August 30, 1982  
ANPP-21722-GHD/BSK

Subject: Interim Report - DER 82-39  
A 50.55(e) Potentially Reportable Deficiency Relating  
To C.E. Valve Limit Switches (Class IE) May Be Below  
Maximum LOCA Flood Level In Containment

INTERIM REPORT - DER 82-39  
POTENTIAL REPORTABLE DEFICIENCY  
ARIZONA PUBLIC SERVICE COMPANY (APS)  
PVNGS UNIT 1

ELEVATION VIEW  
(LOOKING EAST)

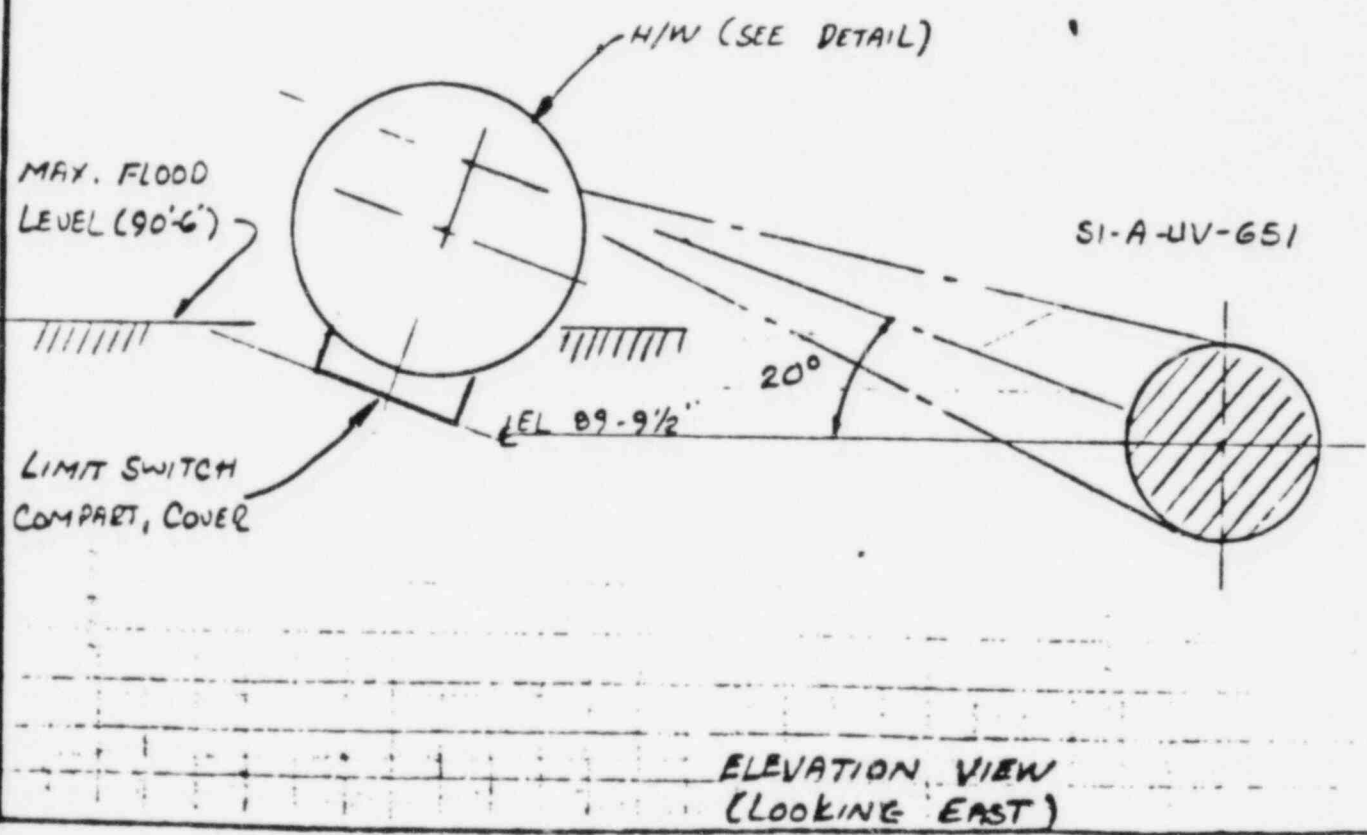
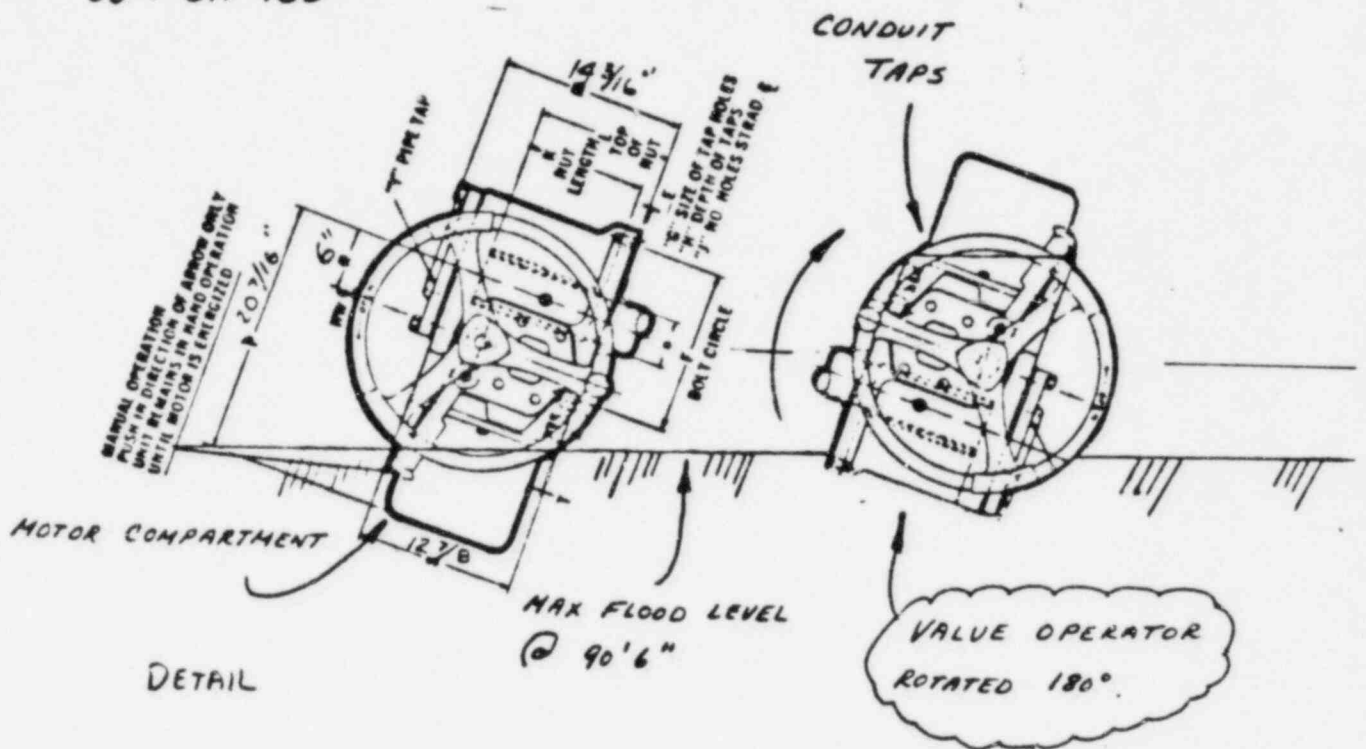
Based on design review and APS observations reported, the following Class IE Electrical Equipment is apparently installed below the maximum containment flood level (Elevation 90 feet 6 inches).

<u>Tag No. (Valve)</u>	<u>IE Equipment</u>	<u>Tag No.</u>
Item 1	SIA-UV-651	Limiterorque - VMO	-
Item 2	CHA-UV-506	NAMCO Limit Switch	CHA-ZSH-506
Item 3	CHA-UV-506	NAMCO Limit Switch	CHA-ZSL-506
Item 4	SIA-UV-682	NAMCO Limit Switch	SIA-ZSL-682
Item 5	SIA-UV-682	NAMCO Limit Switch	SIA-ZSH-682

1. Item 1 - Valve Tag No. SIA-UV-651: Engineering has determined that rotation of the valve operator by 180° will locate the motor and electrical terminations above the maximum containment flood level. A DCP will be initiated to rotate the valve operator as shown on Attachment 1.
2. Items 2 through 5: Currently, the NAMCO Limit Switches supplied with valves CHA-UV-506 and SIA-UV-682 are series EA170 limit switches. These limit switches are not qualified for harsh environment conditions above or below the maximum flood level. Combustion Engineering recognizes this problem and recommends that the EA170 switches be replaced with the series EA180 switches currently being qualified under the C-E Environmental Qualification Program. However,
